Carrier Bridge Pump Station

Metropolitan Sewerage District of Buncombe County
Asheville, North Carolina

ADDENDUM NO. 2

June 13, 2025

CHECKERED PLATE SUPPORT

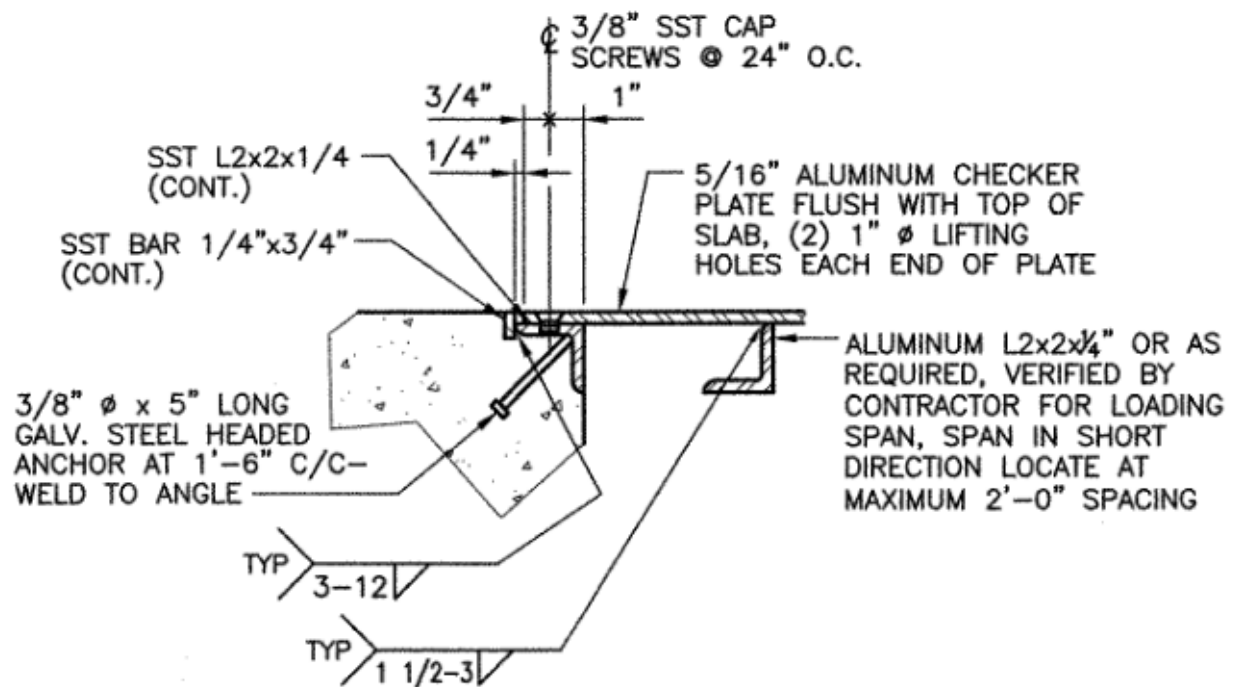
- 2.25. Sheet 10D301, REVISE note "Non Shrink Grout Fillet" to "Concrete Fillet per Detail 7/99S503".
- 2.26. Sheet 99S506, ADD attached detail for the aluminum checkered plat which shall be used at all locations.
